# SUBDIVISION REPORT - CONCEPT/DEVELOPMENT PLAN

► **FILE #:** 3-SI-25-C

► **SUBDIVISION:** 2921 BRADLEY LAKE LANE

► **APPLICANT/DEVELOPER:** MESANA INVESTMENTS, LLC

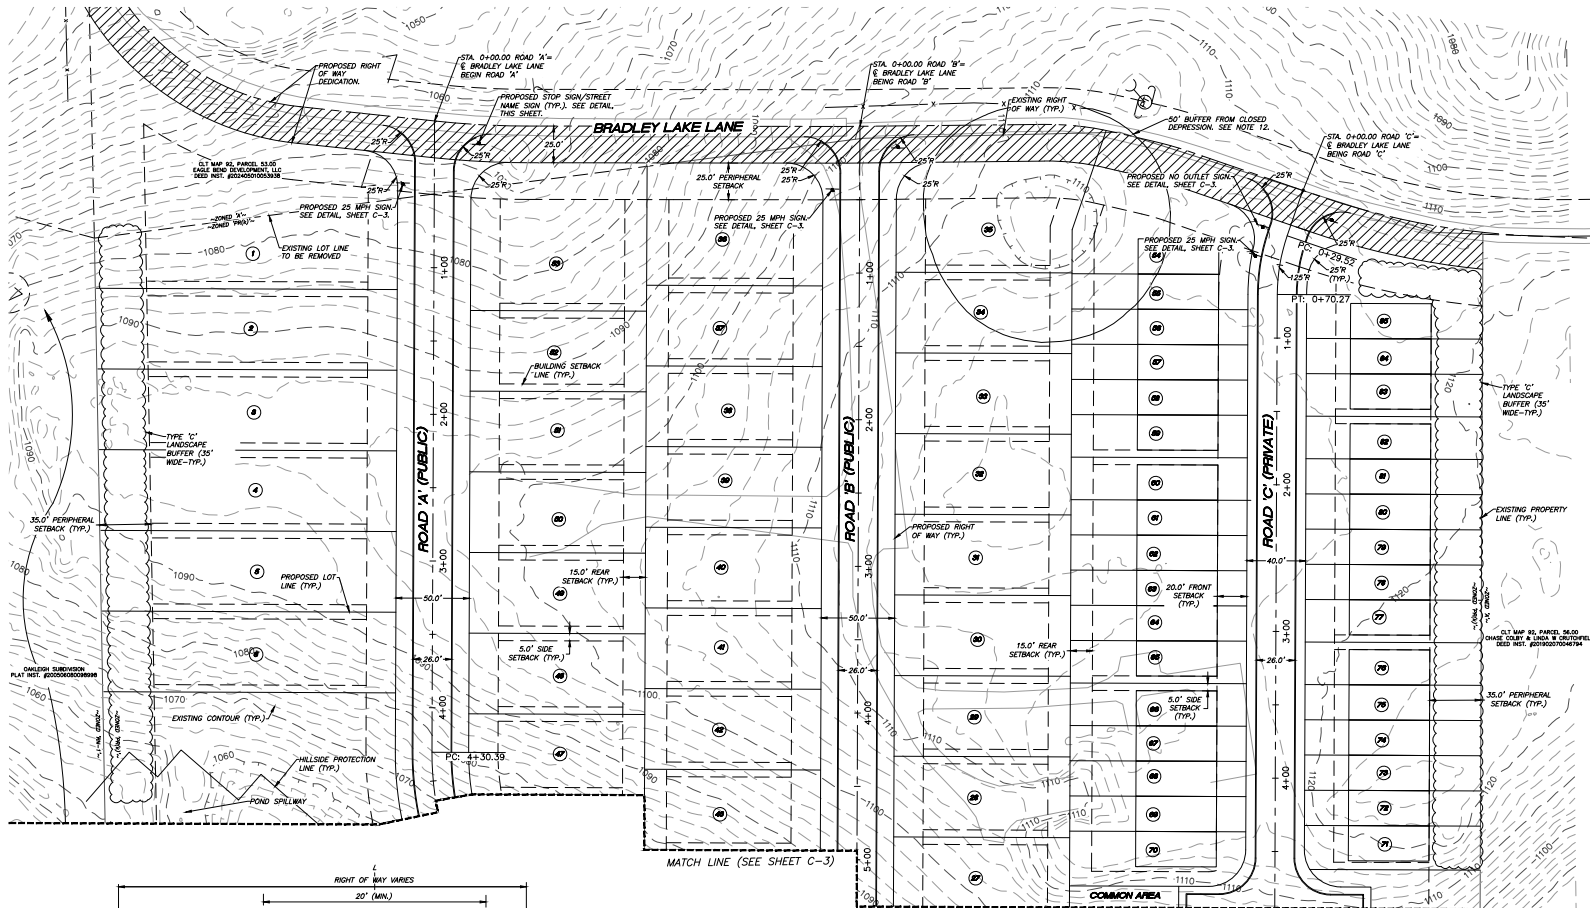
6. Maintaining a 35 ft non-disturbance area and Type 'C' landscape screen (Exhibit C) along the west and south property boundaries, and providing a Type 'C' landscape screen between the attached houses and the east property boundary, per zoning condition #2 (11-K-24-RZ). This does not apply to the portion of the property zoned A (Agricultural). Existing trees that meet the intent of the Type 'C' landscape screen may count toward the screening requirement. A landscape plan must be submitted to the Planning staff for review and approval before grading permits are issued.

11. Installation of the sidewalk connection between the turnaround on Road C and Road B, as shown on the concept plan.

12. Provide the A (Agricultural) and I (Industrial) zoning boundary line on lot 1 on the final plat and include the setbacks for those zones in the plat notes.

PROFILE VIEW: ROAD 'A'  
 1"=50' (HORIZONTAL)  
 1"=5' (VERTICAL)

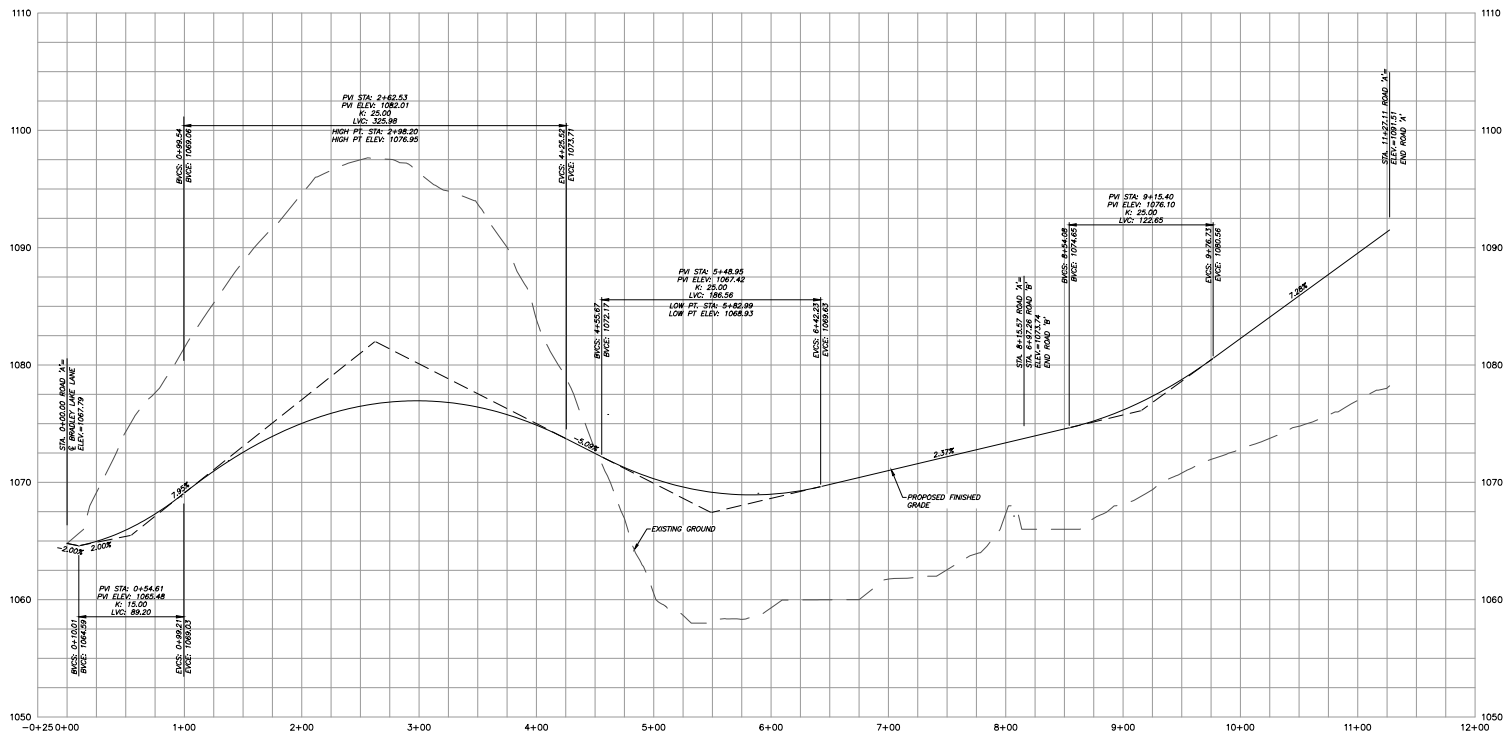
1. Reduce the minimum horizontal curve radius on Road A from 250 ft to 200 ft at STA 4+30.39 (Section 3.04.I.1.b.1)
2. Reduce the minimum street frontage from 25 ft to 24 ft for attached

- **Approve the alternative design standards based on the justification provided by the applicant and recommendations of the Knox County Department of Engineering and Public Works.**

ROADS 'B' AND 'C' PROFILES  
**2921 BRADLEY LAKE LANE**  
SITE ADDRESS: 2921 BRADLEY LAKE LANE (37921)

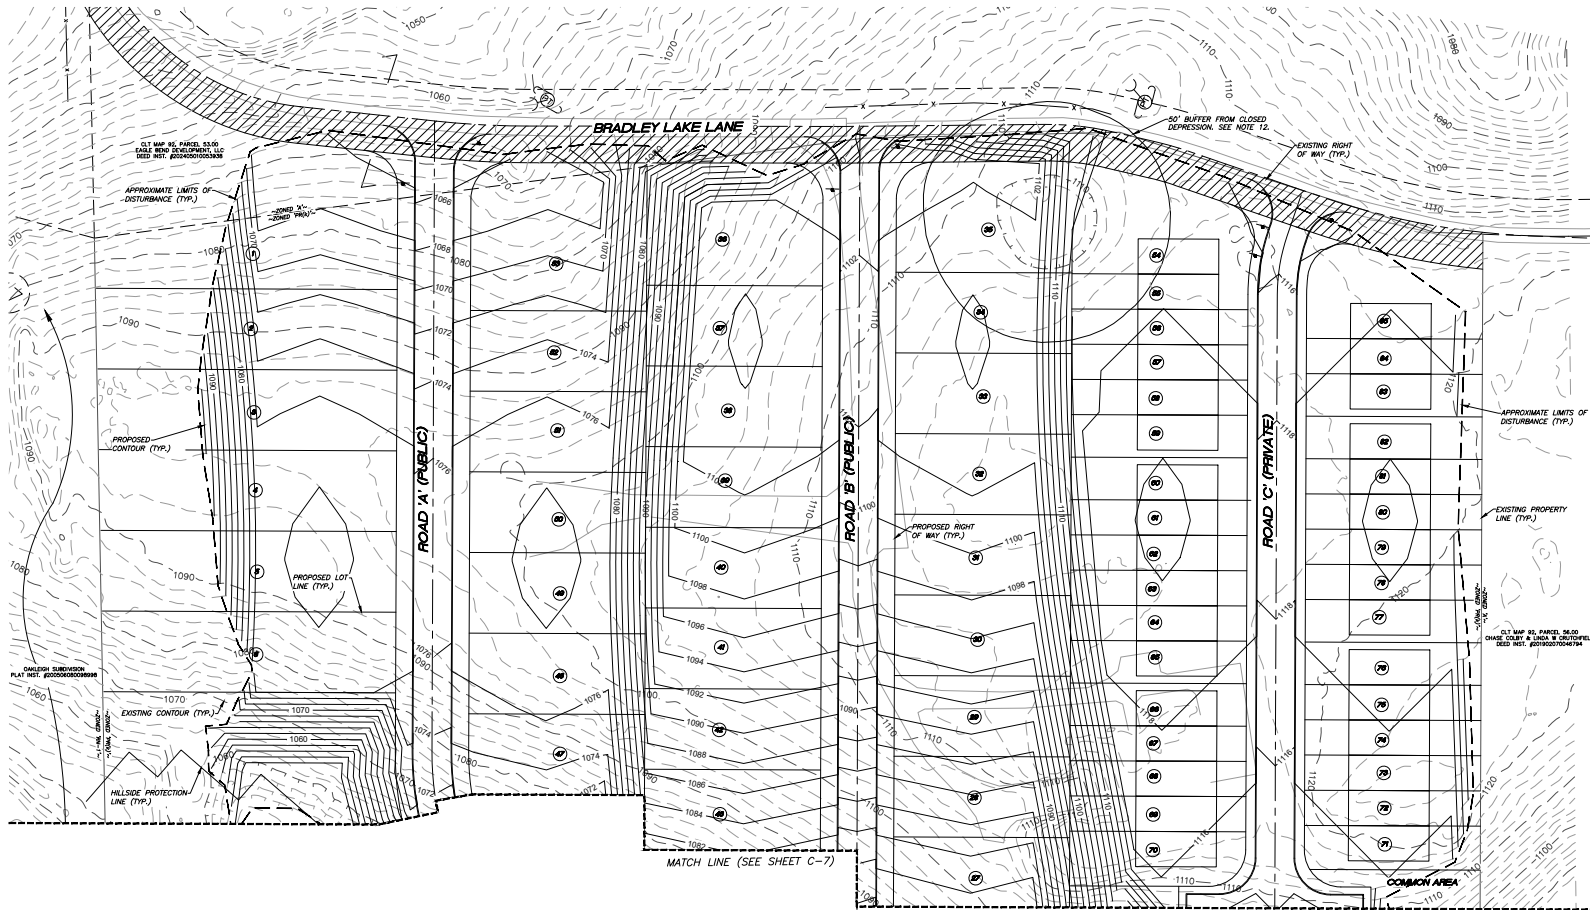
1. Increase the maximum intersection grade from 1 percent to 2 percent on Road A, Road B, and Road C at Bradley Lake Lane (Section 3.04.H.3)
2. Increase the maximum intersection grade from 1 percent to 2 percent on Road B at Road A (Section 3.04.H.3)
3. Reduce the minimum private right-of-way width from 50 ft to 40 ft (Section 3.03.E.3.a)

PRELIMINARY GRADING PLAN

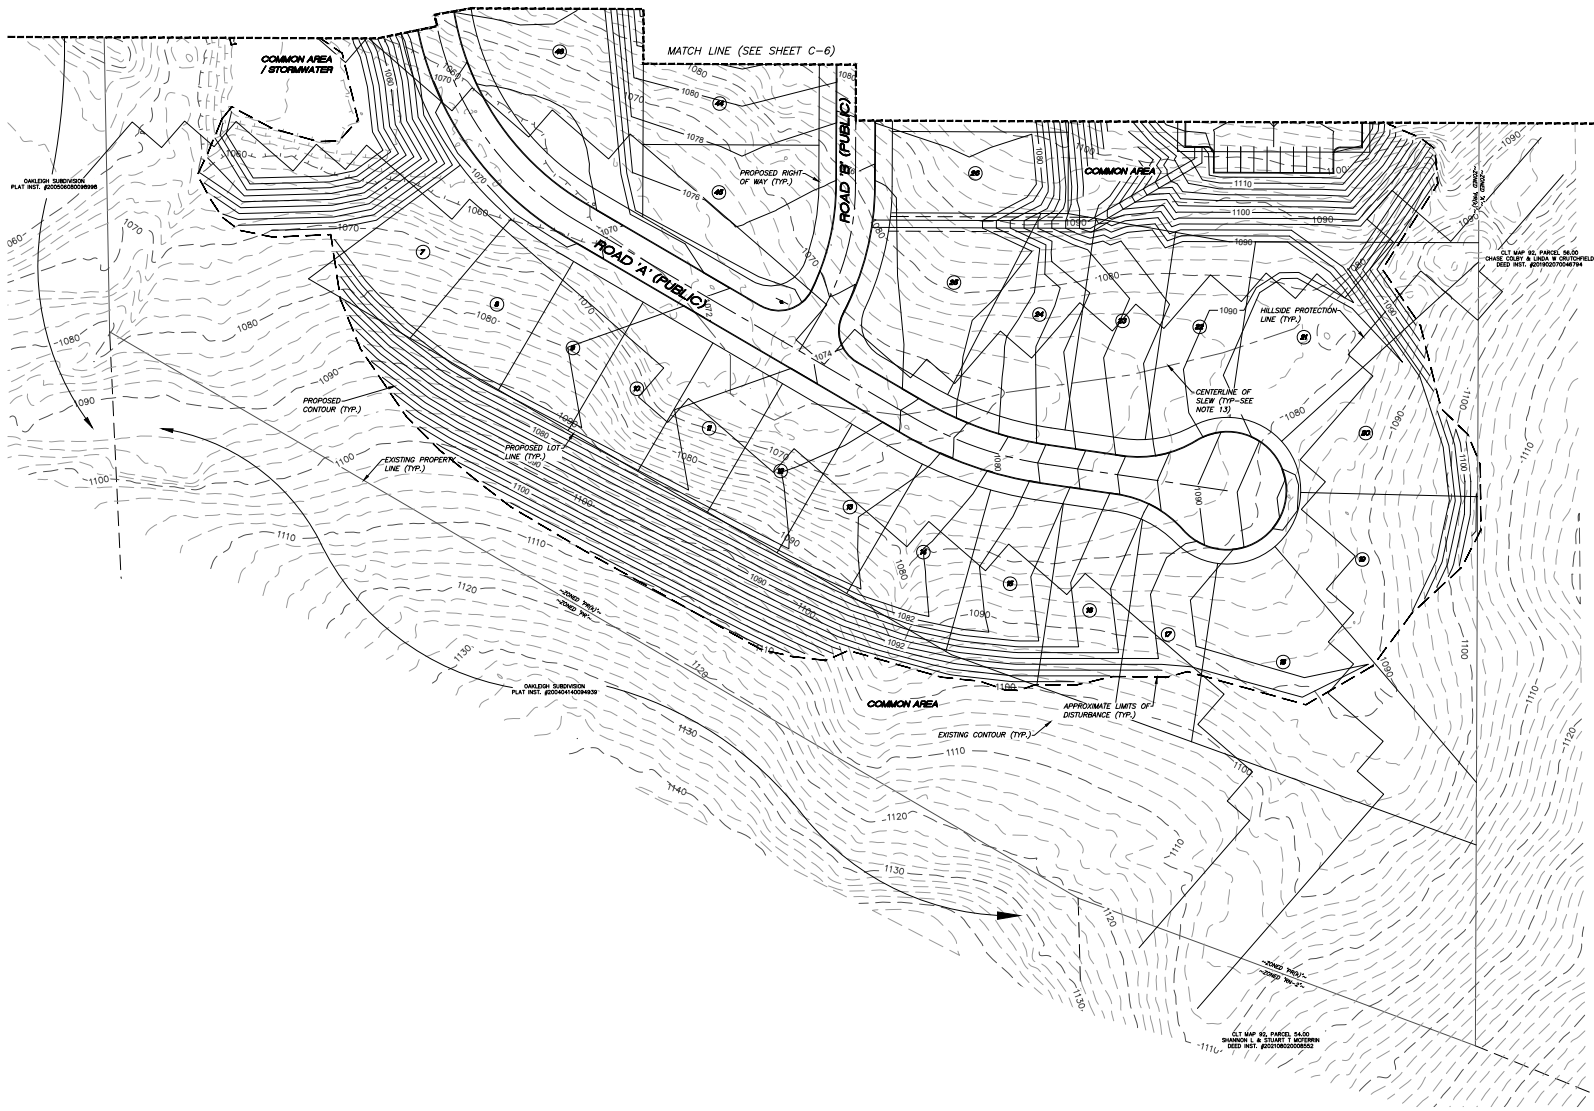
1. Meeting all applicable requirements of the Knox County Zoning Ordinance and the four zoning conditions.
2. The maximum height of the attached dwellings shall be 35 feet.
3. The land disturbance within the HP (Hillside Protection) area shall not exceed the proposed 12.8 acres.
4. If the right-of-way dedication along Bradley Lake Lane is less than 25 ft from the road's centerline, as proposed on the concept plan, the peripheral setback will be increased in depth the same amount, provided, however, it shall not be required to exceed 35 ft.

A. The 19.79-acre site has approximately 17.18 acres in the HP (Hillside Protection) area. The slope analysis recommends a disturbance budget of 11.25 acres in the HP area, and this proposal disturbs approximately 12.8 acres. Staff is recommending a condition that the grading in the HP area be no more than the proposed 12.8 acres. This is consistent with Policy 7, which encourages development practices that conserve and connect natural features and habitat.
